Amendment to the Drawings:

FIG. 3

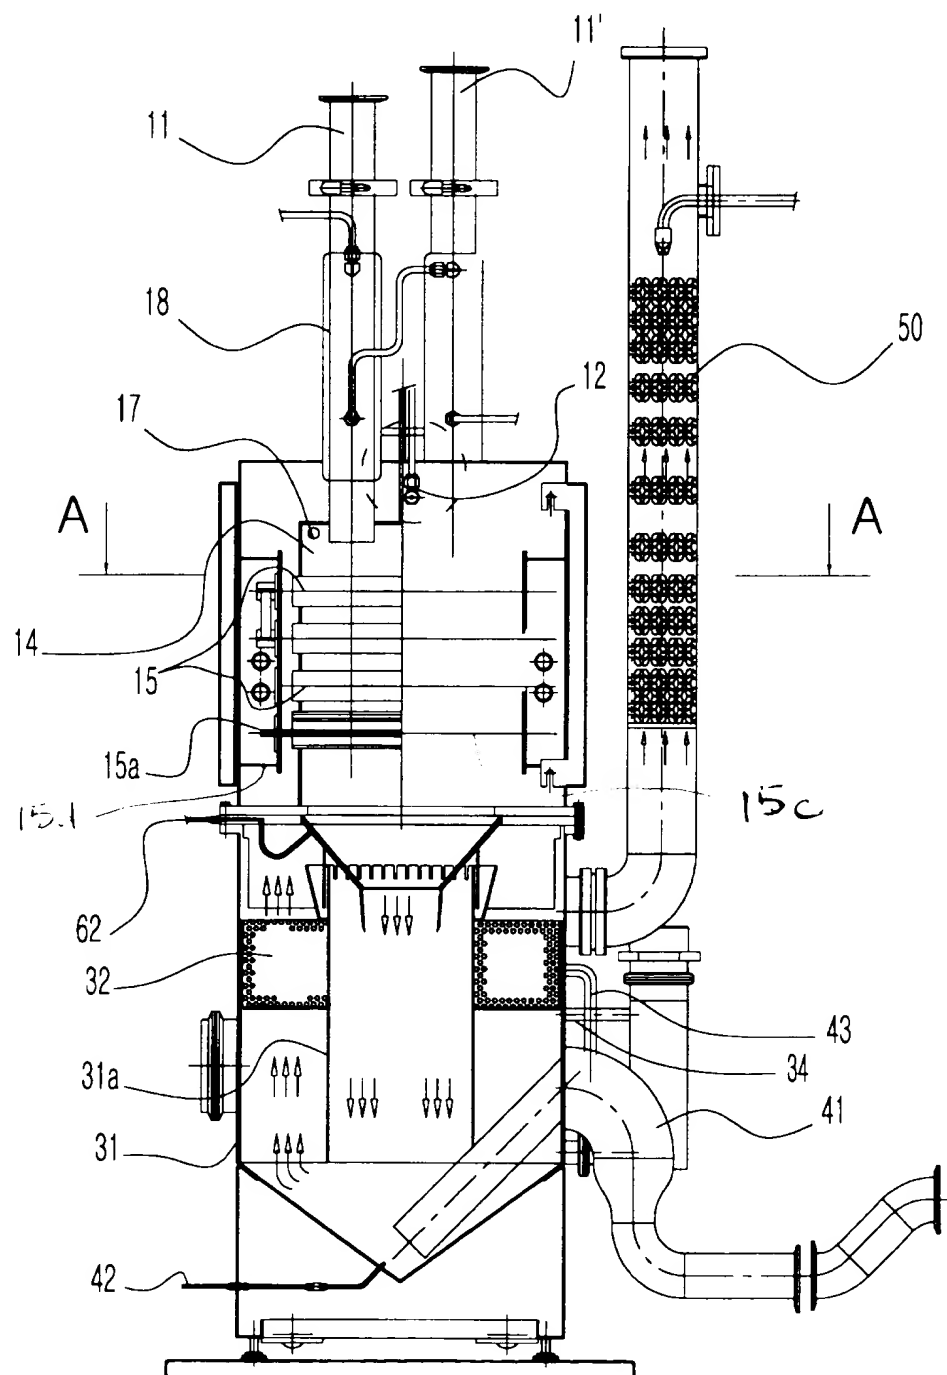
The attached sheet of Drawings includes changes to FIGS. 3-4 and replaces the original sheets of Drawings including FIGS. 3-4. The indicated changes to FIGS. 3-4 will be incorporated into the final, formal drawings to be filed when the application is allowed. As will be described in more detail below, the amendment to the Drawings is submitted for clarification purposes only, and thus, does not present new matter. Pursuant to 37 C.F.R. 1.121, it is requested that the Examiner approve the submitted changes.

As shown on the attached Drawings, reference characters "15c" and "15d" were added to FIG. 3 to point out the electrical power conductor and clamp components, respectively. Reference character "15d" was also added to FIG. 4 to illustrate the relationship between the clamp (15d) and nitrogen nozzle 16. Support for the amendment to FIGS. 3-4 may be found in the Substitute Specification (see, amended paragraph above) and in dependent claim 12, as originally filed. As such, the amendments to the Drawings do not introduce new matter.
